Project Number: SP2018-005
Project Name: 615 Highland Drive
Project Type: SITE PLAN
Applicant Name: HUCKABEE
Owner Name: ROCKWALL, I S D
Project Description:

SP2018-005 -SITE PLAN FOR REINHARDT ELEMENTAR SCHOOL
SITE PLAN - LOCATION MAP =

Discuss and consider a request by Crystal Vasquez of Huckabee on behalf Will Salee of the Rockwall Independent School District for the approval of a site plan for a school on a 6.983-acre parcel of land identified as Lot 1, Block A, Rockwall School Addition #2, City of Rockwall, Rockwall County, Texas, zoned Single Family 10 (SF-10) District, addressed as 615 Highland Drive, and take any action necessary.

SUP SITE PLAN

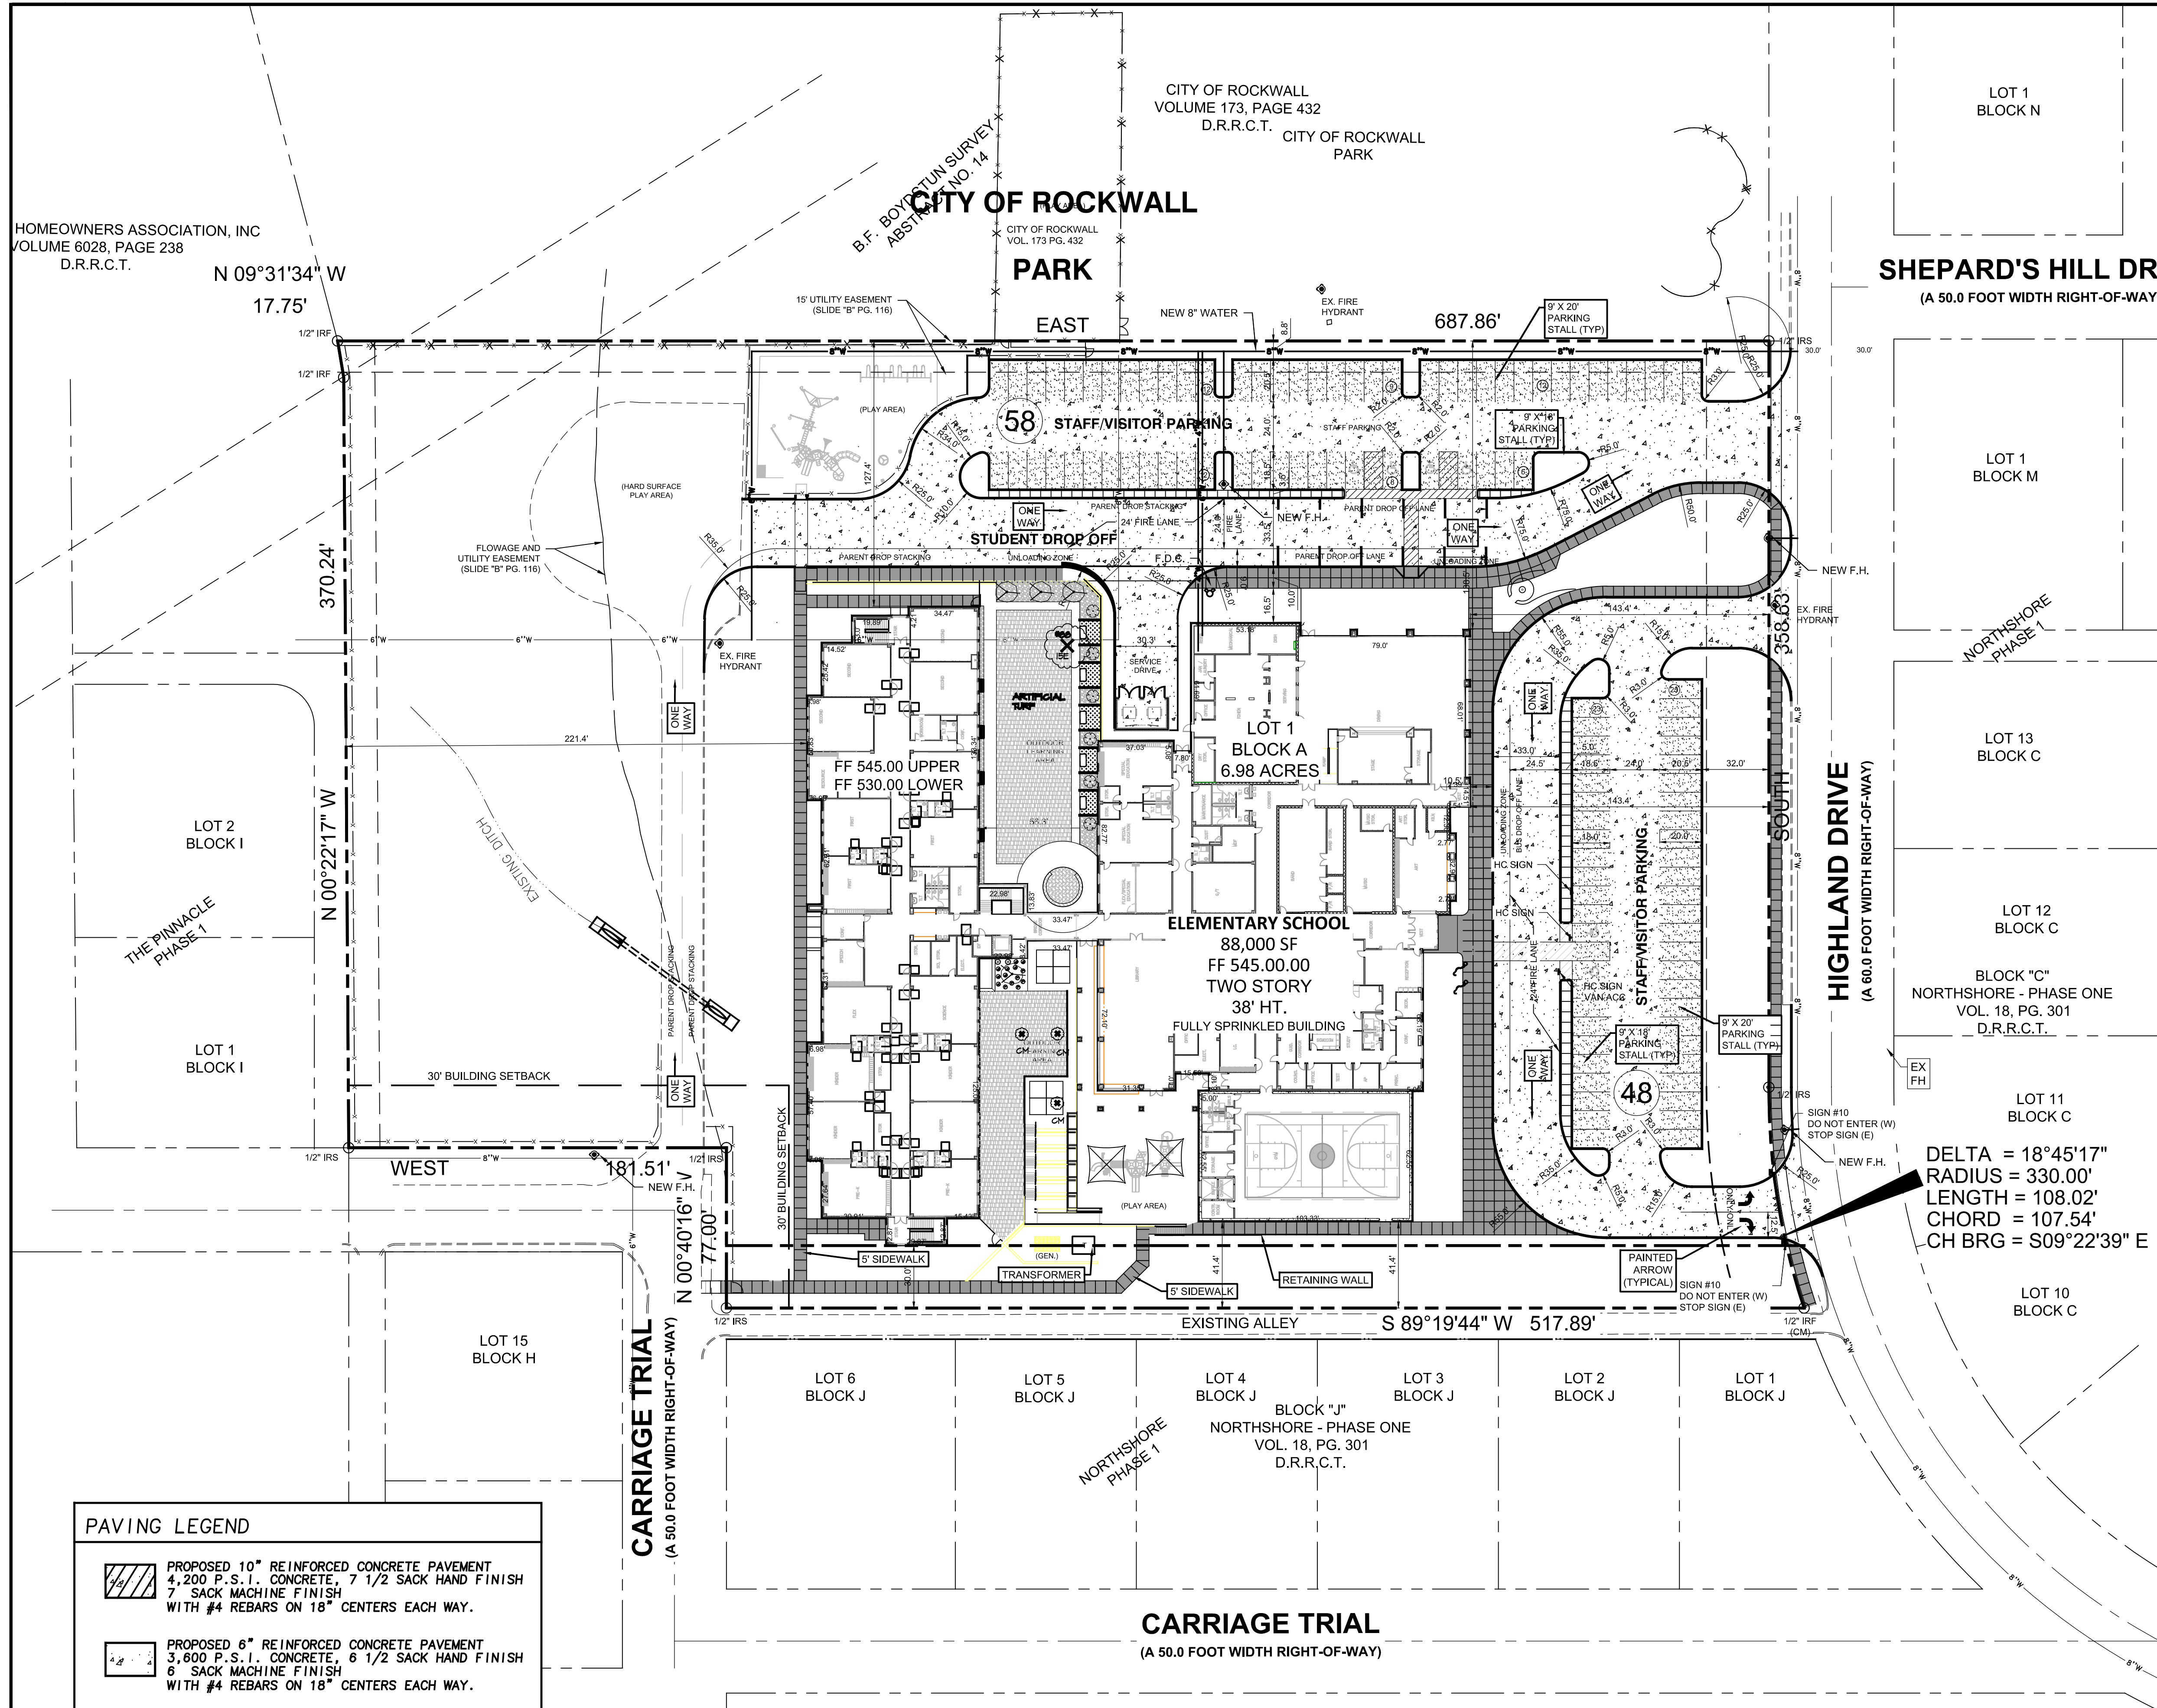
** Please address the following Planning Comments for each plan and resubmit revised plans by date requested:						
Site Plan:						
1. Re-label all firelane as "24-ft Firelane and Public Access Easement" – (if utilities exist, add utility easement in label).

2. Remove labels indicating "Parent Drop Stacking" & "Bus Drop-Off Line" as these are located within the dedicated 24-ft Firelane.						
3. Dumpster enclosure walls are to be a minimum of 6-ft in height with materials to match the primary structure; including the use of an opaque gate and a self-latching mechanism. Provide detail and label as such.						
Landscape Plan:

ARCHITECTURAL EXTERIOR BUILDING MATERIALS

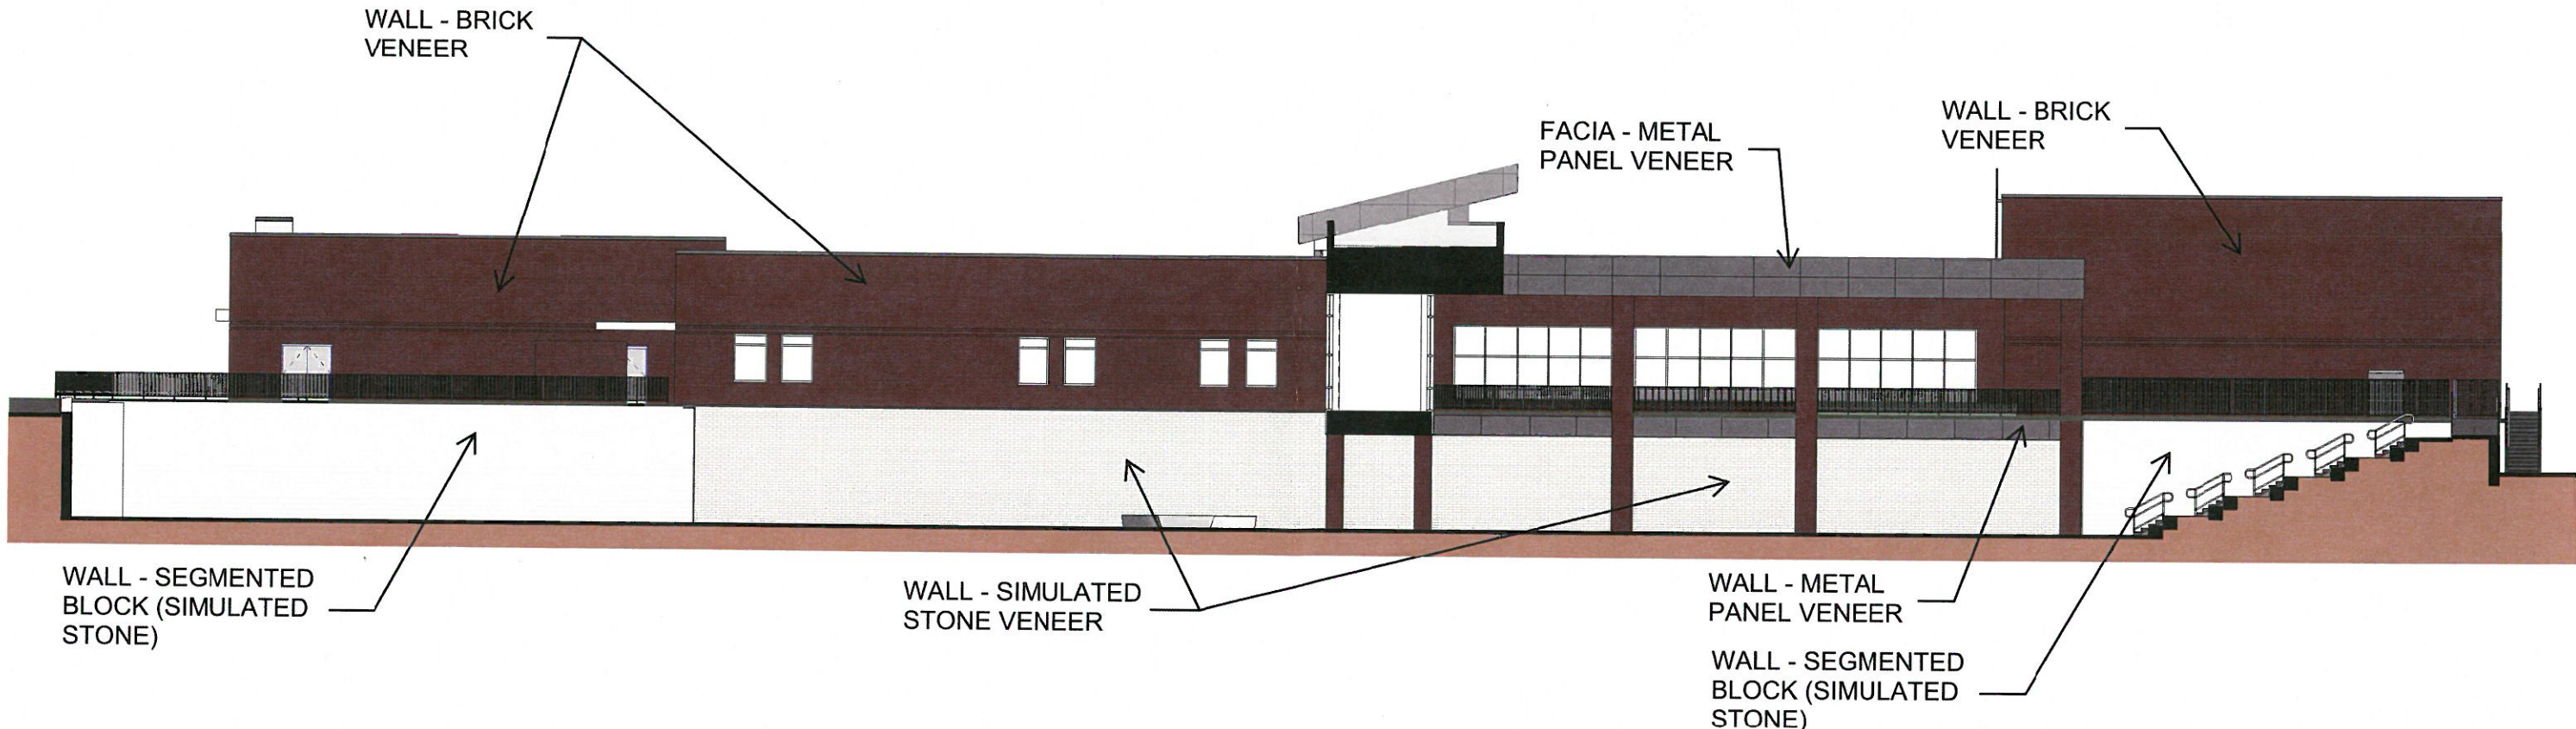
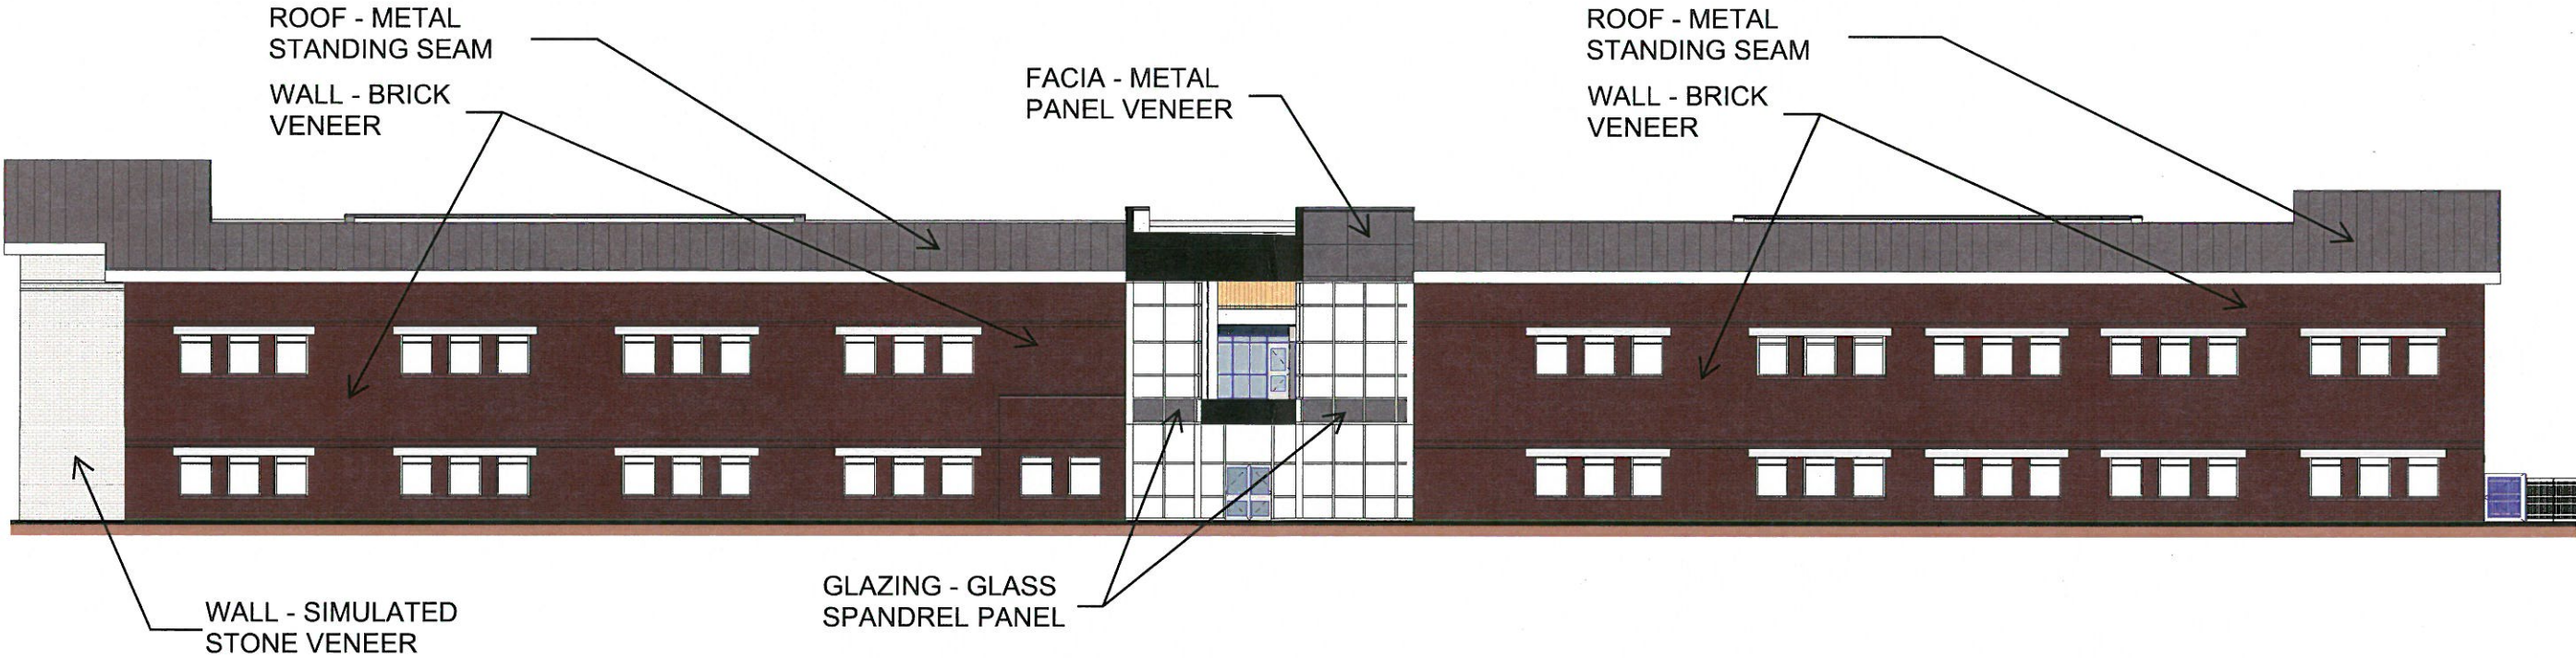
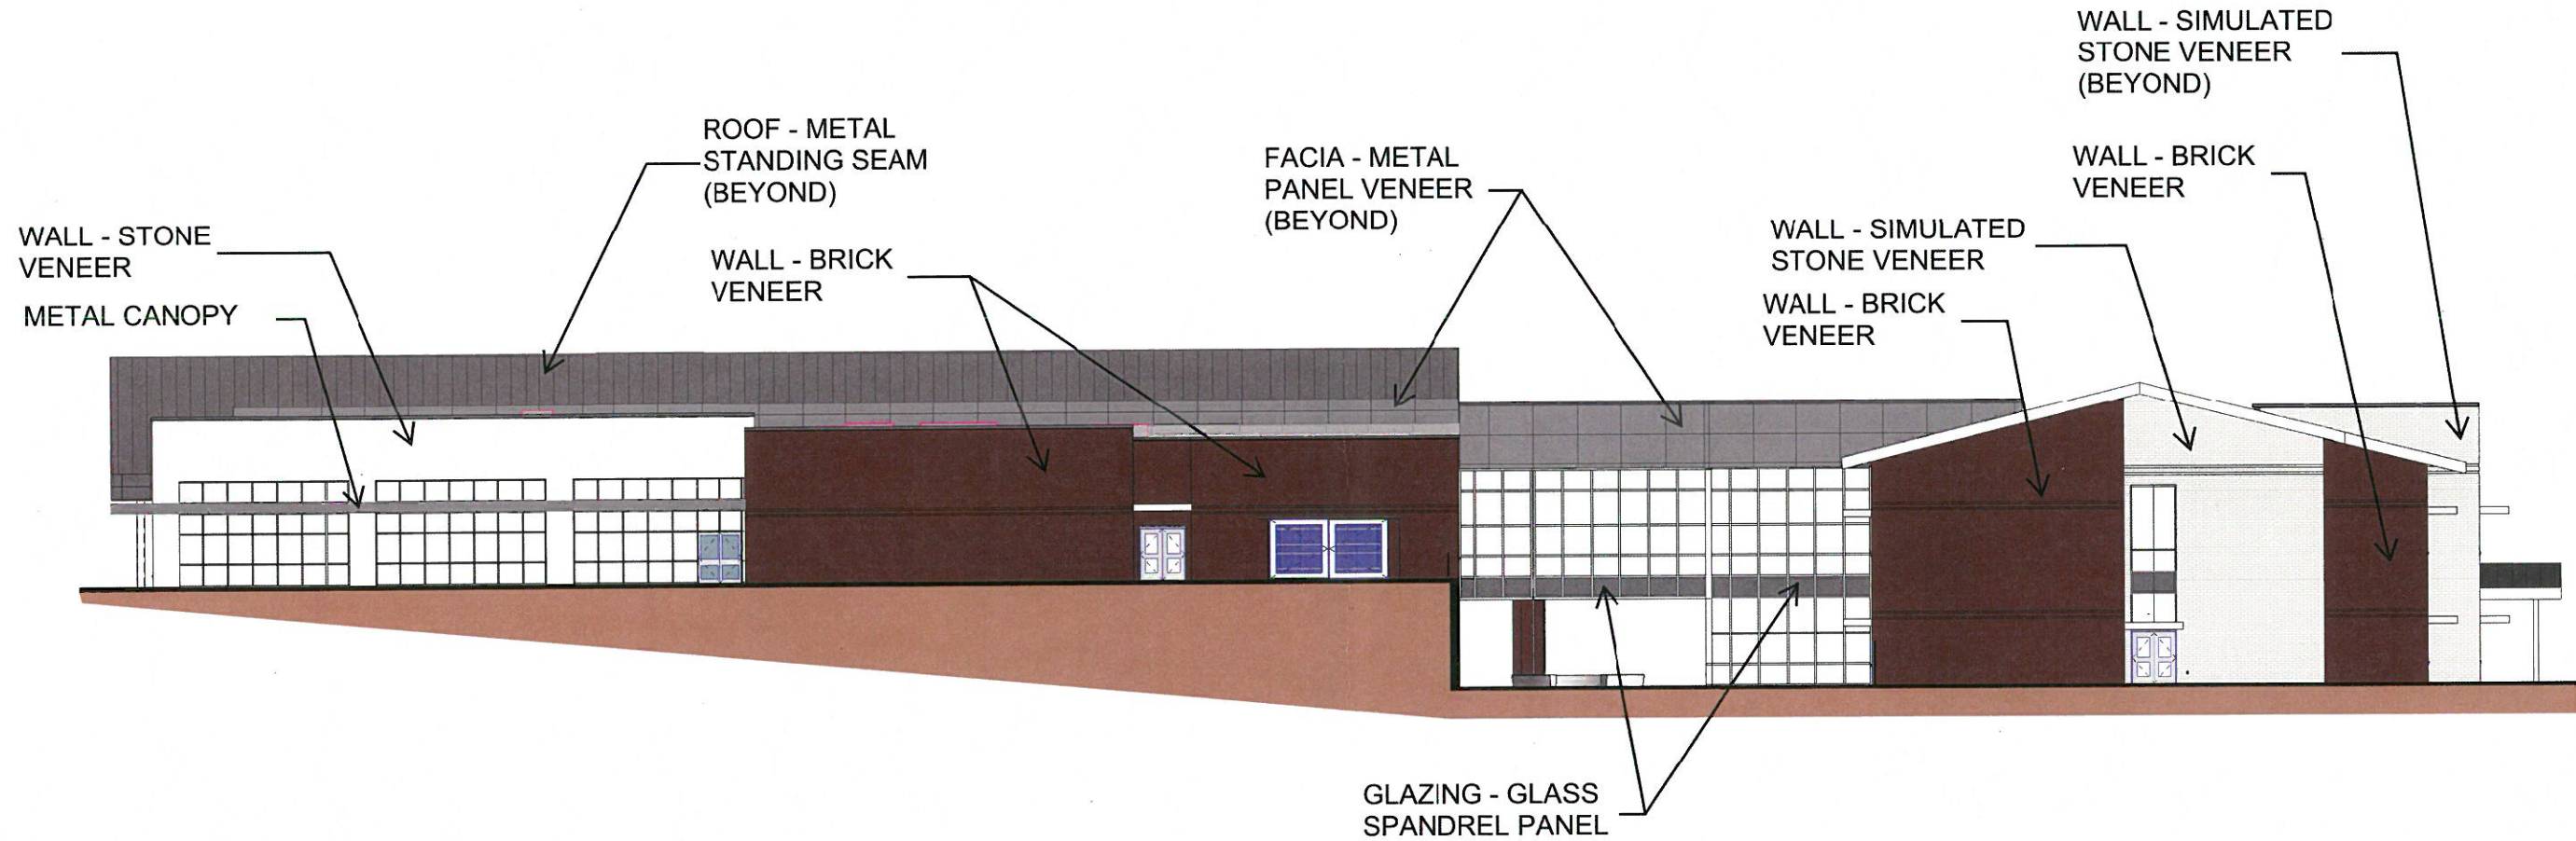
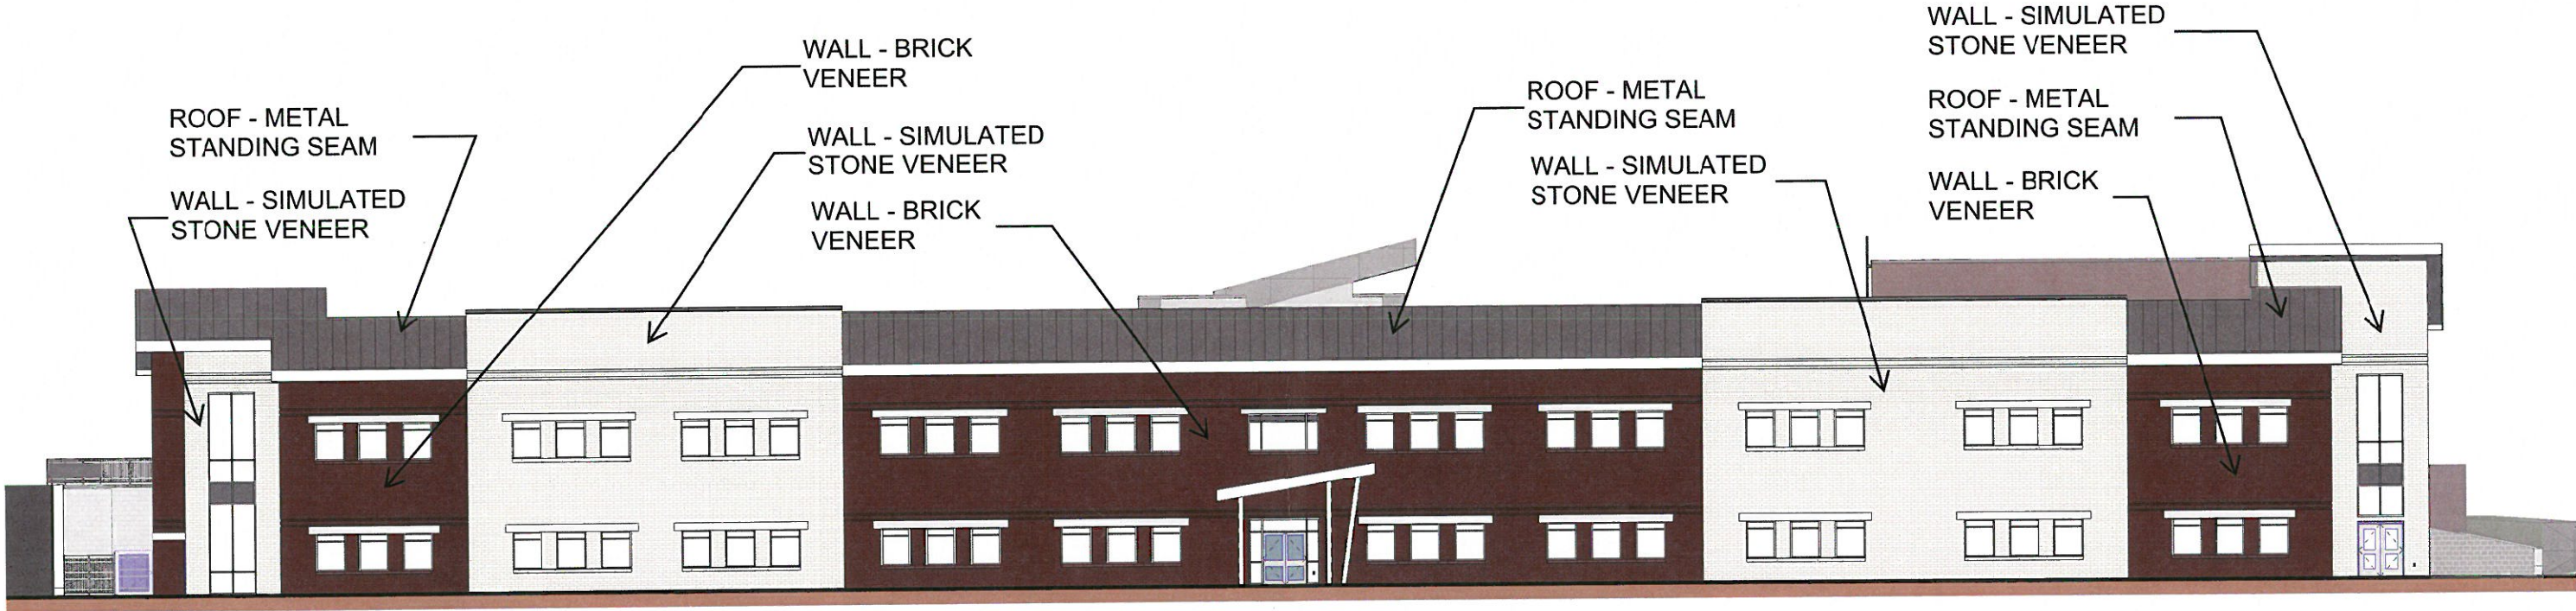
Type of Review / Notes	Contact	Sent	Due	Received	Elapsed Status	Remarks
Building Elevations:						
1. All roof-top mechanical equipment requires screening from rights-of-way and adjacent properties. Provide a roof plan indicating location of units and/or dash-in RTU's on elevations. Provide detail of screening mechanism to be used.

2. Why are there two (2) drawing submitted for the east and west elevations?						
3. The following requires approval of an exception to the masonry standards by the City Council due to the "simulated stone" appearing to be thin brick per the materials sample board submitted and as indicated above:
